U.S. GEOLOGICAL SURVEY  
Reston, Virginia 20192

As requested by the Federal Emergency Management Agency (FEMA), attached is the review by the U.S. Geological Survey (USGS) of the model prepared for a reach of the Congaree River in South Carolina. The area covered by the model is for the reach of the Congaree River spanning the area north and south of highway I-77 embankment in Columbia, South Carolina.

The following documents were reviewed by Janice M. Fulford of the U.S. Geological Survey for technical clarity and accuracy:

**Figure 1.** Model boundaries, bridge opening locations and dike break locations from the Exponent RMA2 model of the Congaree River.

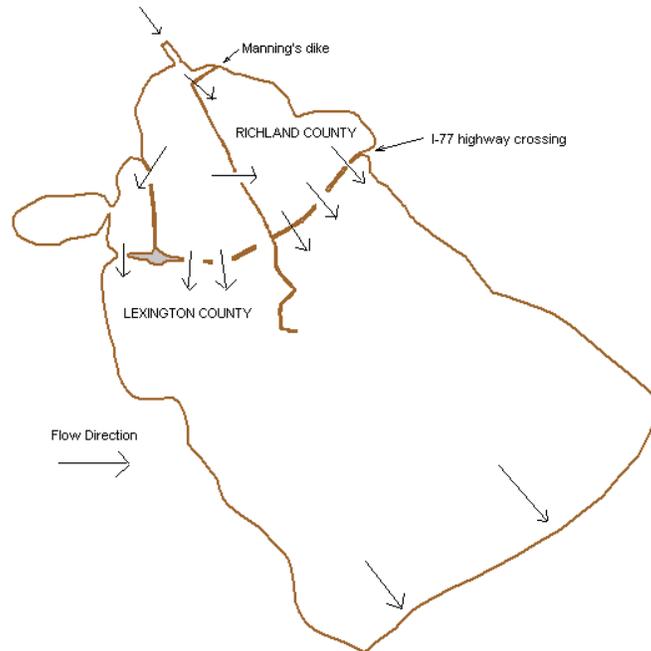
**IV.** The Exponent model does not accurately determine the portion of the 100-year flood flow passing through the Manning's dike breaks onto the Richland side of the flood plain. The Exponent model has local computational errors that produce significant errors in the flow computed through the bridge and dike openings. The sum of the flows passing through the dike breaks and the Lexington I-77 bridge openings (figure 1) should equal the total discharge of 292,000 cubic feet per second (cfs). Also, the flow through the dike breaks should equal the flow through the Richland I-77 bridge openings, and the sum of the flows passing through the I-77 bridge openings should equal the total model flow of 292,000cfs. The mass conservation error computed by summing the Manning's dike breaks and Lexington county bridge openings discharges and comparing it to the 100-year flood flow is about 17%. The finite-element method used by RMA2 does not guarantee local mass conservation. It is standard finite-element modeling practice to include flow (continuity) check lines to determine if mass is being adequately conserved locally. Poor local mass conservation can be due to poorly constructed model grids. Table A lists the discharges through the various bridge openings and dike breaks computed by using the Exponent model flow check lines and one hand calculation. Note that the flow through the dike breaks differ by 16% from the flow through the Richland Bridges, indicating that mass is not being properly conserved at the embankment openings.

**Table A.** Discharges in cubic feet per second through various I-77 bridge openings and levee breaks as computed by the Exponent model for the 100-year flood flow of 292,000 cubic feet per second. (\*hand computation from RMA2 results)

Levee Breaks	Discharge, cubic feet per second	Percent of flood flow
Manning's Dike Breaks (8489. 44,800.)	53,289.	18.3
I-77 Bridge Openings	Discharge, cubic feet per second	Percent of flood flow
Lexington County Bridges (3276.* 2356. 39,410. 143,200.)	188,243.	64.5
Richland County Bridges (53,830. 6888. 2356.)	63,074.	21.6

**Figure 2.** Comparison of roughness values and locations used for the Exponent and FEMA RMA2 models of the Congaree River.

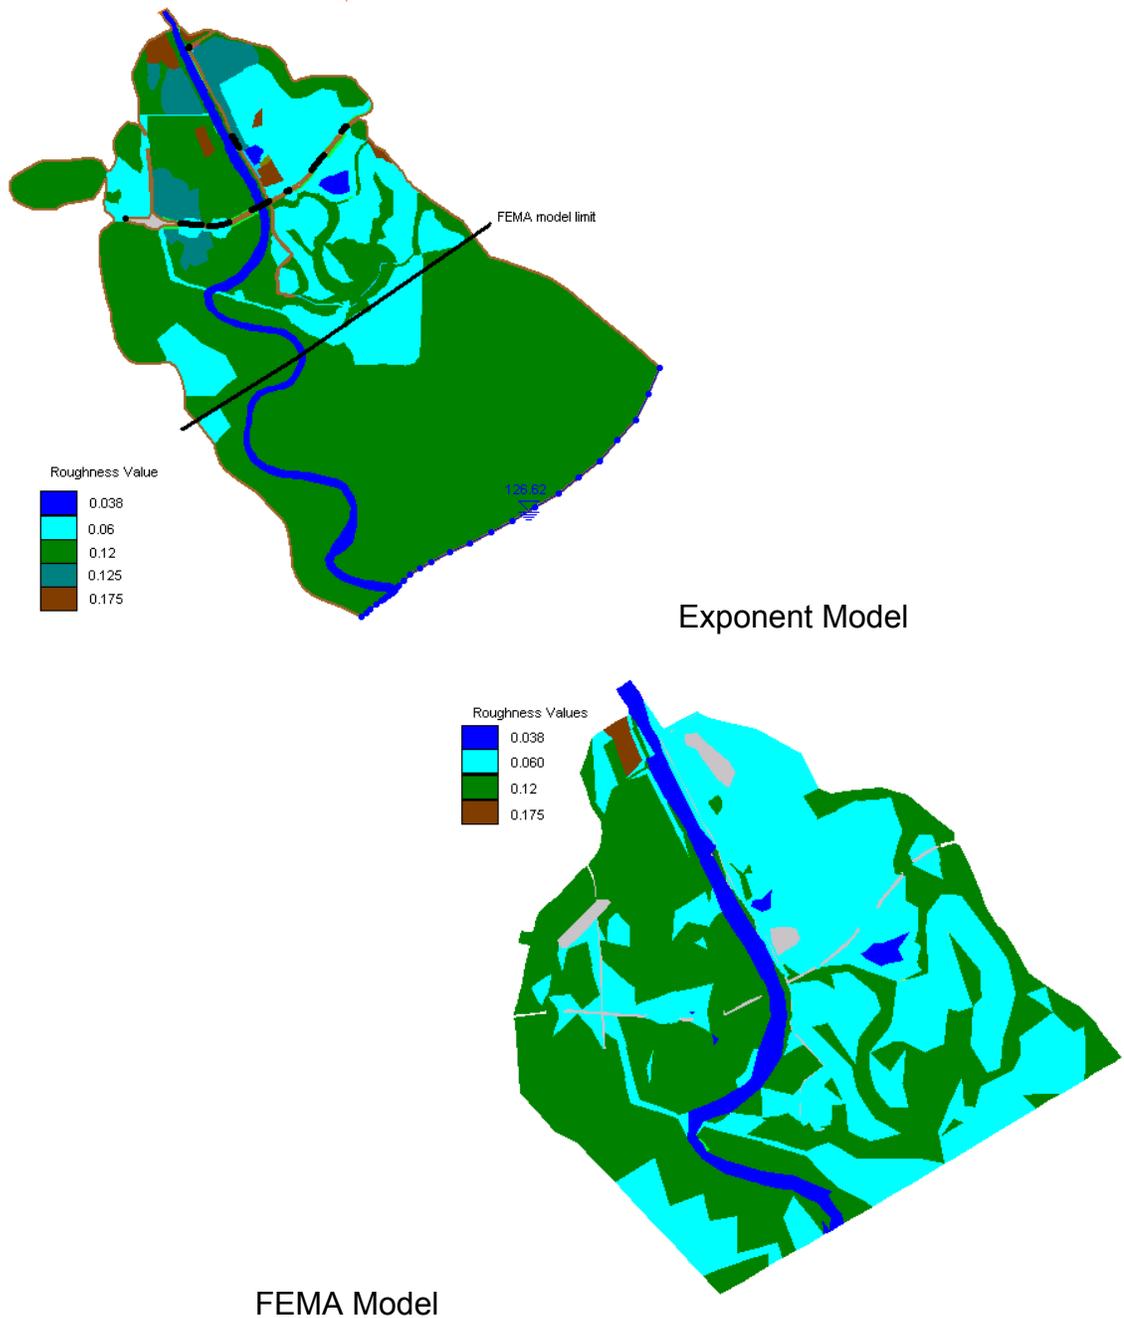
V. The Exponent model has increased the roughness coefficients (from 0.06 to 0.125) for elements just south of the portion of the Manning's dike that runs east west near the northern (upstream) limits of the model. Elements just north of Manning's dike in this area were also assigned larger roughness values (from 0.06 to 0.175). No information is given to support increasing the roughness values in this area of the model. Aerial photos (dated 01.21.1994 found on the web at terraserver.homeadvisor.msn.com, jpeg file attached NElevee.jpg) appear to show open cropland south of the levee. The area in the photo is similar in appearance to model areas that have roughness values of 0.06. The recent photo (dated 3.22.1999, file name Congaree-SmallerFile.tif) used by the FEMA report does not seem to show a change in land use for that area. A small portion of the area in question can be seen in the recent photo just above the white text, 1"=3000'. The roughness values used in this area should be confirmed. Roughness

values can significantly change flow directions and flow depths. A comparison of the roughness values used for the Exponent model with those used for the FEMA model is in figure 2.

Figure 3. Rating curves estimated for Carolina Eastman gage.

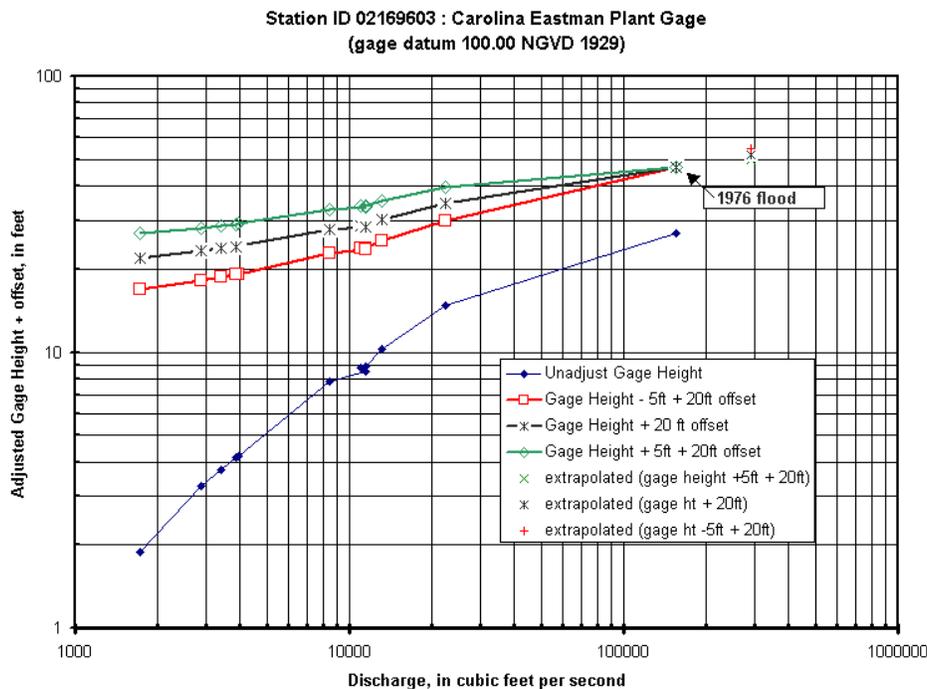
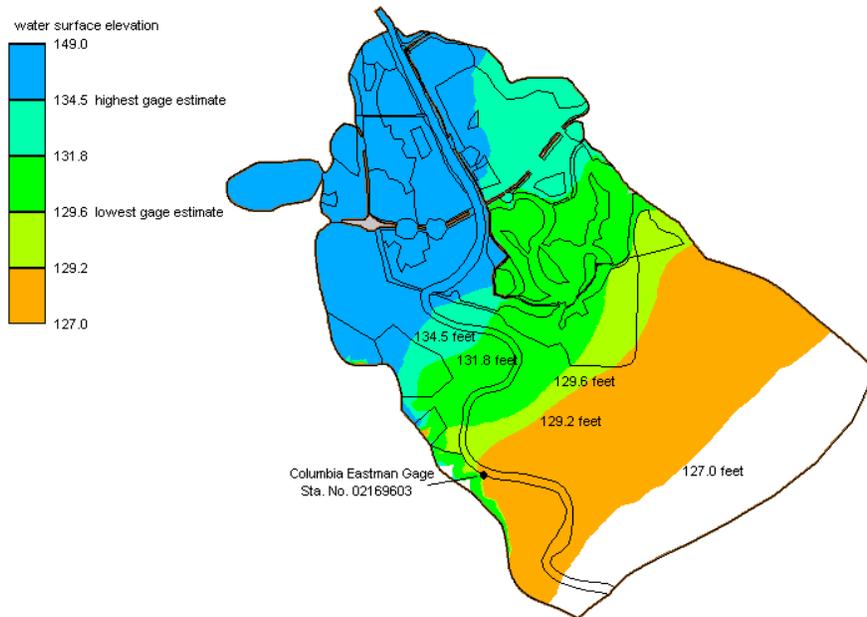
**VI.** The water-surface elevations computed by the Exponent model may be too low because of the outflow water-surface elevation used. Exponent Inc. used a constant water-surface elevation of

126.2 feet at the outflow boundary that may be from 0.5ft to 5.3ft too low when compared to water-surface elevations estimated from stage-discharge measurement analysis. The reason for selecting 126.2 ft was not documented in the materials accompanying the Exponent model. It is likely that this value is based on 1-dimensional (HEC2) model runs that used an energy slope for the boundary condition. A stage-discharge (rating curve) analysis was made on the measurement data collected by the USGS between March 1986 and April 1987 at the Carolina Eastman gage and included the 1976 flood elevation at the gage. Because the gage datum is referenced to a topographic map, gage heights associated with USGS discharge measurements at the gage have a possible error of  $\pm 5$  ft. The elevation at the gage for the 1976 flood was assumed to be accurate for the analysis. Figure 3 shows the rating curves developed from discharge measurements and the 1976 flood information. One curve, of gage height, has no corrections for datum and offset adjustments. The other three curves shown are computed with offsets of 20ft and referenced to a vertical datum of 100ft. Extrapolation of the three curves plotted with an offset gives a range of estimated water-surface elevations at the Carolina Eastman gage for 292,000cfs of 129.62ft to 134.53ft with 131.85ft for no datum correction. Because the Exponent model outflow boundary is located downstream of the gage, contours of the water-surface elevations estimated for the Carolina Eastman plant gage for the 100-year flood flow were plotted to check the boundary conditions used in the Exponent model. Figure 4 shows that the estimated elevations from the rating curve analysis are 0.5 to 5.3 ft higher than those computed by the Exponent model at the gage. Boundary conditions used by any flow model should be carefully selected and documented. Sensitivity of the model results to the likely range of water-surface elevations at the downstream outflow boundary should be investigated when the outflow water-surface elevation is not well known.

**Figure 6.** Contour plot of the Exponent model flow depths in feet for the 100-year flood flow.

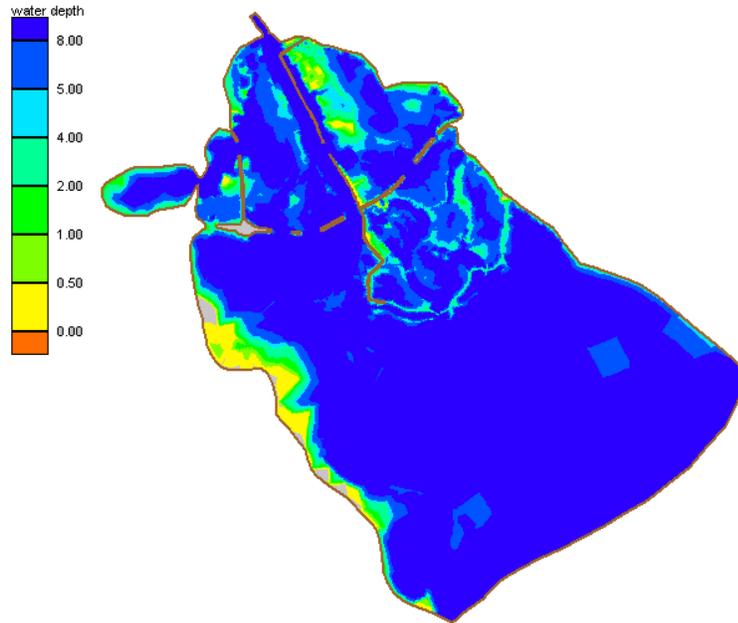
**VIII.** The conclusion by Exponent Inc. and [REDACTED] Consulting that the Richland side of the floodplain is not a floodway is not supported by the Exponent model results. Results from the Exponent model indicate that the Richland side of the flood plain conveys a significant portion of the 100-year flood flow. Table B lists the percent of total bridge flow passing through the main bridge opening and through the Lexington and Richland county relief bridges as computed by the Exponent model. Flow through the Richland relief bridges (63,074 cfs) is larger than the flow through the Lexington relief bridges (45,042. cfs). Additionally, contour plots of unit-width discharge show that a significant portion of the flow passes through the Richland side of the flood plain (figure 5). Most of the entire floodplain, including the Richland side, is inundated with flow depths of 8 ft or more (figure 6). Only 65% of the total modeled flow (292,000cfs) passes through the openings in the I-77 embankment on the

Lexington County side of Manning’s dike. This leaves a significant portion (35%) of the flow passing through the Manning’s dike breaks or computationally unaccounted for by the Exponent model (due to mass conservation problems).

**Figure 7.** Force per unit width in units of slugs per second squared computed from the Exponent RMA2 model for a flow of 292,000 cubic feet per second.

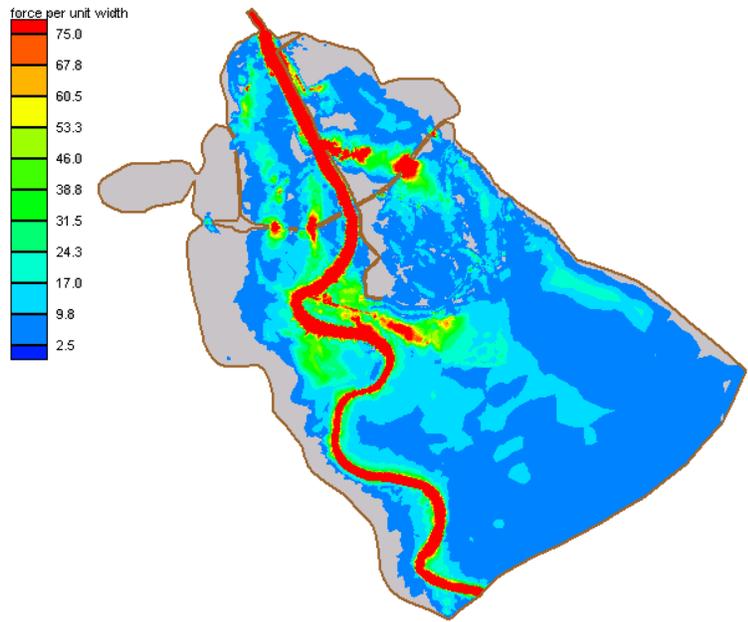
**IX.** The definition of a floodway used in the Exponent Inc. and [REDACTED] Consulting reports is questionable because the definition ignores the effects of any flow due to a natural or man made feature that is not parallel to the main channel. Flow distribution in broad floodplains is determined by the location of bridge openings in highway crossings and other topographic or roughness features in the flood plain. The Exponent Inc. and [REDACTED] Consulting definition restricts the floodway to be adjacent and parallel to the main channel and ignores significant flow features that aren't parallel and adjacent to the main channel. For example, if a flood plain had a distributary branch that carried one half of the flow but at a 90-degree angle to the main channel, that distributary would never be part of a floodway using the Exponent Inc. and [REDACTED] Consulting definition because flow in the distributary would not be parallel to the main flow. FEMA does recognize that significant flow patterns can occur in a floodplain that do not flow parallel to the main channel. The FEMA "Study Contractor Guidelines and Specifications" recommend, "Split-flow analyses should be considered when flows overflow the banks of the main stream and take a different flow path." Also the FEMA document states, "2-D computer models may be used for shallow flooding areas, split flow situations, and complex bridge sites." The I-77 highway crossing of the Congaree floodplain is a significant feature affecting flow distribution on the floodplain. Placement of the main bridge and the relief bridges largely dictate how the flow north and south of the highway crossing is distributed. The effect of the Richland relief bridges on flow patterns should not be ignored because FEMA "Study Contractor Guidelines and Specifications" dictate for uncertified levees that "the 100-year flood elevations will be recomputed as if the levee did not exist" and because Manning's dike is expected to "likely fail in a 100-year flood"(Appeal Resolution for Congaree River in Richland and Lexington Counties, South Carolina, FEMA, September 26,2000) based on geotechnical studies of the levees. The force exerted by water during a flood could be one of many factors considered when determining a floodway. Figure 7 is a contour plot of force per unit width computed from the Exponent model results using the equation  $F = \frac{1}{2} \rho v^2$  where F is force,  $\rho$  is the density of

water ( $1.94 \text{ slugs/ft}^3$ ),  $y$  is the flow depth at a model node and  $v$  is the velocity magnitude at a model node. This plot shows that significant forces are produced by the flow present in the Richland County side of the Exponent model.
